DA Submission regarding Development Application No. DA2019/0699 at 19 Subject:

Joseph Street, Avalon Beach

REFERENCE: DA2019/0699

ADDRESS: 19 JOSEPH STREET, AVALON BEACH

Figure 4: View towards carport on subject site, looking north-east from the living room of the dwelling at No. 17 Joseph Street

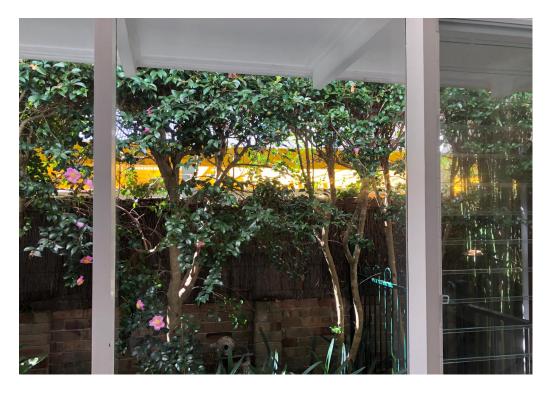
Of particular concern to my client is the bulk and scale of the unauthorised carport as it adjoins the south-western boundary of the site, substantially impacting the internal amenity of my clients' living room (Refer to Figures 2-8).

Accordingly, we request that the carport be amended to provide a minimum setback of 1.0m from the south-western boundary, with screen planting provided along the boundary.
